TRUCK MEDIUM MC2 (UNIMOG) - ALL CARGO VARIANTS
TRAY FLOOR HEADBOARD ASSEMBLY

MODIFICATION INSTRUCTION

FIG 1 - WELDING DETAILS

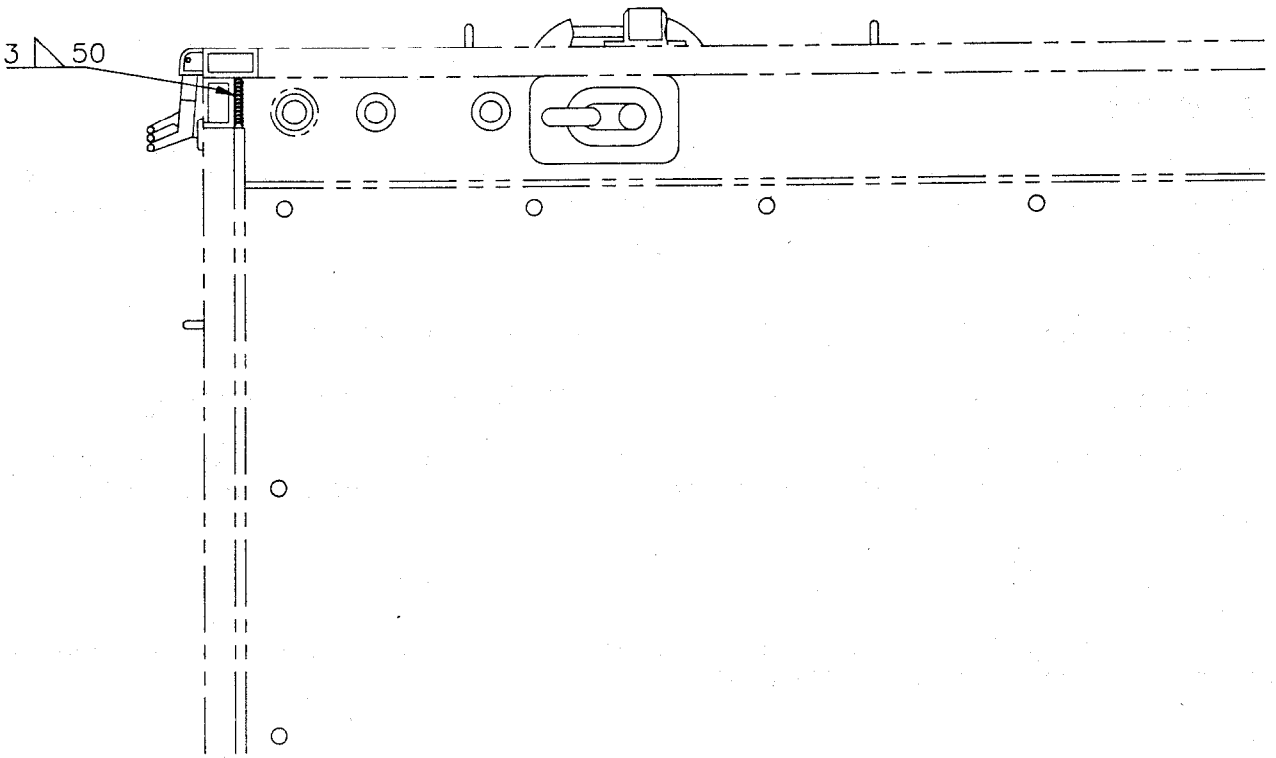
1. This instruction details additional welding to the vertical posts on either side of the headboard to strengthen and prevent cracking of the existing welds.

7. To carry out the modification proceed as follows:
 - a. Clean the area where the vertical posts meet the tray floor.
 - b. Weld both the right and left hand posts as shown in Fig 1, using NSN 3439-66-016-2218 Electrode Welding 2.5mm.
 - c. Repair any cracked welds in accordance with WKSP B 002-1.
 - d. Paint all exposed areas as detailed in WKSP B 700.
8. Modification Record Plate. On completion of the modification, deface the numeral 21 on the vehicle modification record plate.
